L-2012-444

Re: Turkey Point Units 3 and 4  
Docket No. 50-250 and 50-251  
License Renewal Pressurizer Surge Line Welds Inspection Program  
Response to Request for Additional Information

**Responses to the NRC Request for Additional Information**

Figure 1, Comparison of Fatigue Crack Growth with R-ratio = 0.

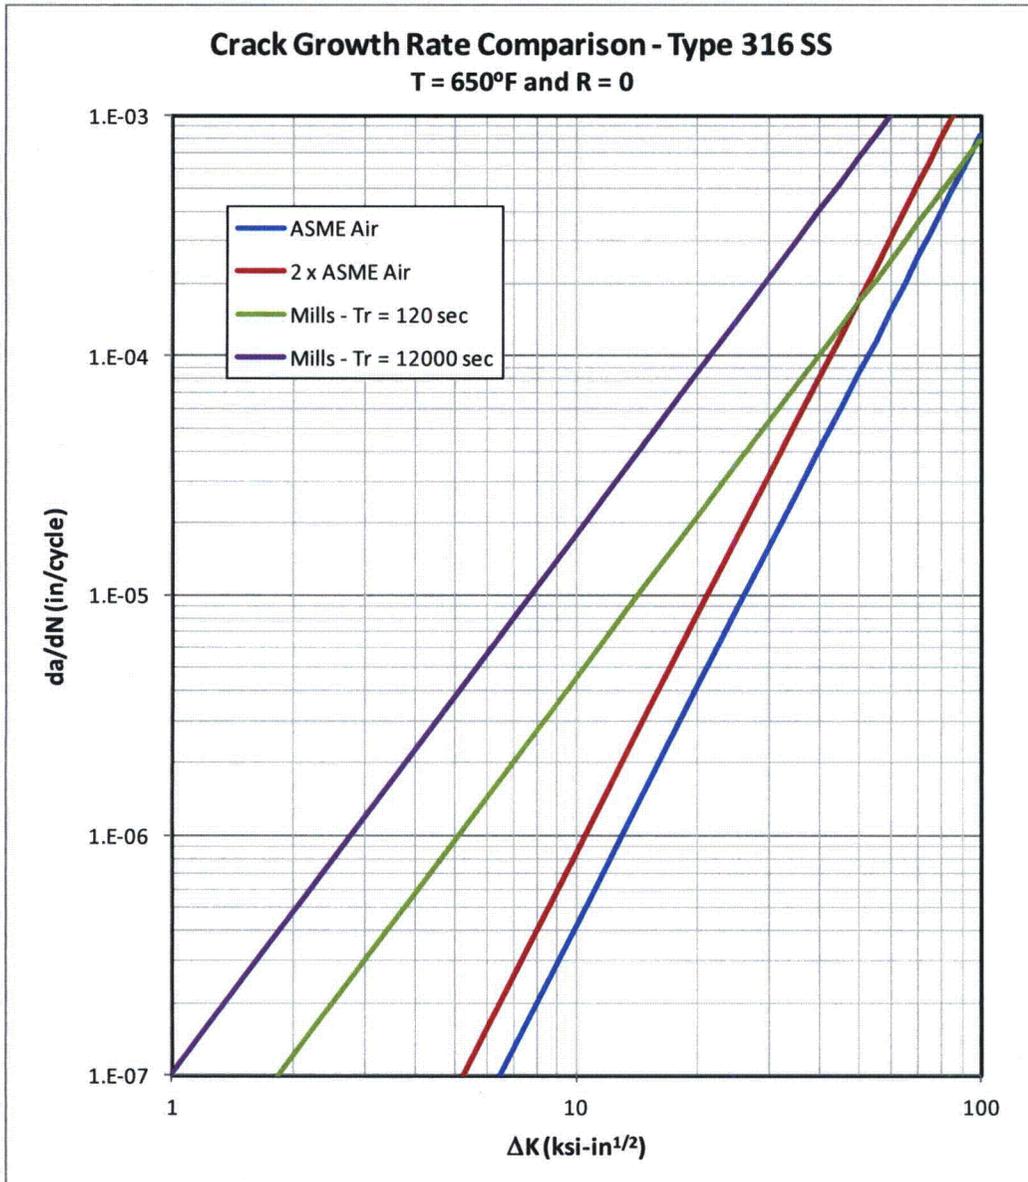
Provide a technical basis to justify that use of the referenced formulation is conservative with respect to the calculation of the fatigue crack growth rate in a pressurized water reactor environment. Describe how this formulation takes into account the parameters discussed in Section XI, Subarticle C-8410, including temperature, ratio of the minimum stress intensity factor to the maximum stress intensity factor associated with the transient stress range, and the environment.

Comparisons of the crack growth rate used in the evaluation and 2 times the ASME Code air curve is shown in Figure 1 and Figure 2.

For a low rise time of 120 seconds, it can be seen from Figure 1 that, for an R-ratio equal to zero, the formulation used in the evaluation produces more conservative crack growth results than using the ASME Code crack growth curve with a factor of 2 for  $\Delta K$  values less than 50 ksi-in<sup>1/2</sup>. Similarly, Figure 2 shows that, for a low rise time of 120 seconds and an R-ratio equal to 1, the formulation used in the evaluation produces more conservative crack growth results than using the ASME Code crack growth curve with a factor of 2 for  $\Delta K$  values less than 30 ksi-in<sup>1/2</sup>.

Both Figures 1 and 2 show that, with a rise time of 12000 seconds, the formulation used in the evaluation is conservative compared to 2 times the ASME Code crack growth rate in air for  $\Delta K$  values less than 70 ksi-in<sup>1/2</sup>. In the evaluation, a conservatively large rise time of 15732 seconds representing a heatup transient was used for all the cyclic loads and the maximum calculated  $\Delta K$  was 39.3 ksi-in<sup>1/2</sup>. Therefore, the formulation used in the evaluation is conservative for the calculation of the fatigue crack growth of stainless steel components in a pressurized water reactor environment.

Figure 1. Effect of Strain Rate on SCC of Alloy 600 and Types 304 and 316 Austenitic Stainless Steels (SS) (Ref 1)

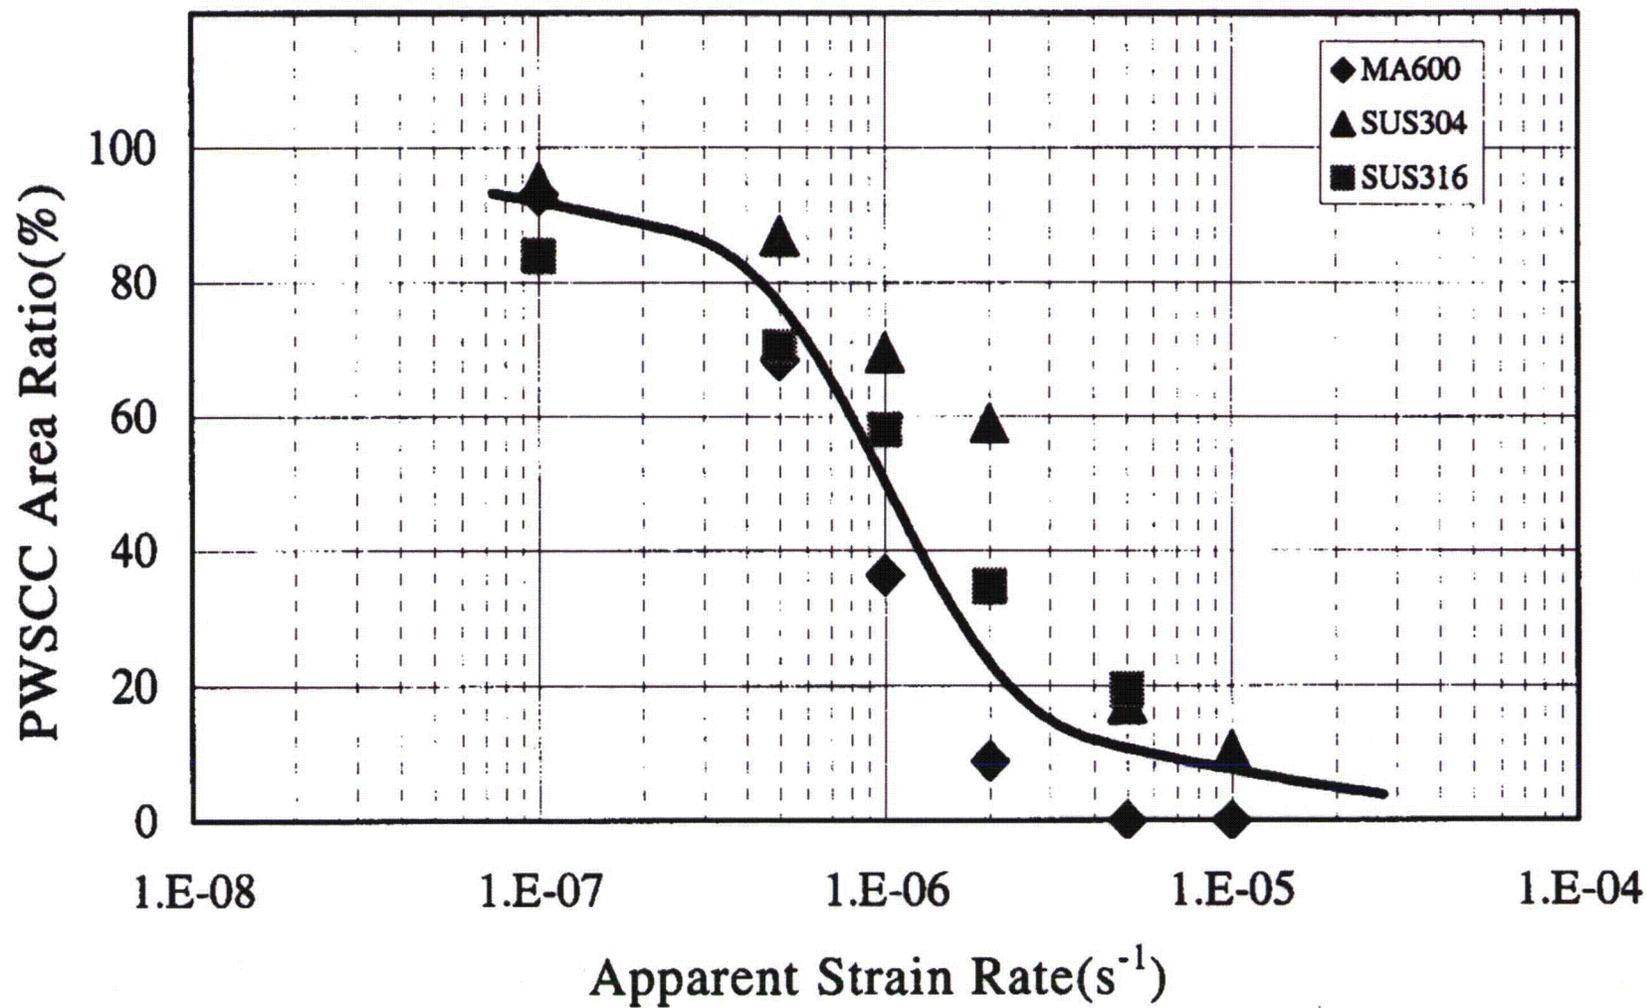
Describe how and justify that the flaw growth evaluation accounted for the effects of stress corrosion cracking. Alternatively, provide the basis for not considering the effects of stress corrosion cracking in the evaluation.

As illustrated in Figure 1, austenitic stainless steels are susceptible to stress corrosion cracking (SCC) in PWR environments in a similar fashion as Alloy 600 (Reference 1). To distinguish the SCC of nickel base alloys in PWR environments, i.e., primary water stress corrosion cracking (PWSCC), a new SCC term, i.e., low potential stress corrosion cracking (LPSCC) is often used to describe the SCC of austenitic stainless steels in PWR environments.
